Environmental Health Coalition

Public Hearing (9/16/09)
Once Through Cooling
Deadline: 9/30/09 by 12 noon

RE: Environmental Health Coalition Comments -OTC Policy

Figure 13: Larval Fish Concentrations at Southern OTC Facilities

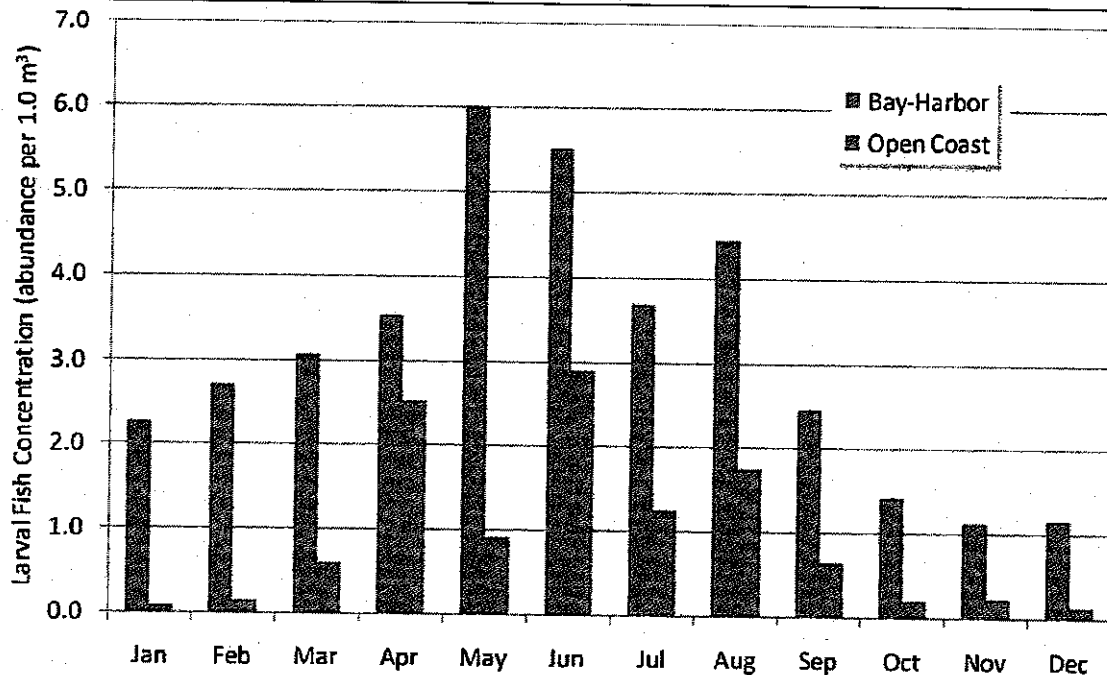
This is key for San Diego Bay given the extreme 'back bay' shallow water nature of where the water is taken from and discharged. Again the DSED shows the significant differences in the larval fish abundance between bay harbor environments and open ocean.
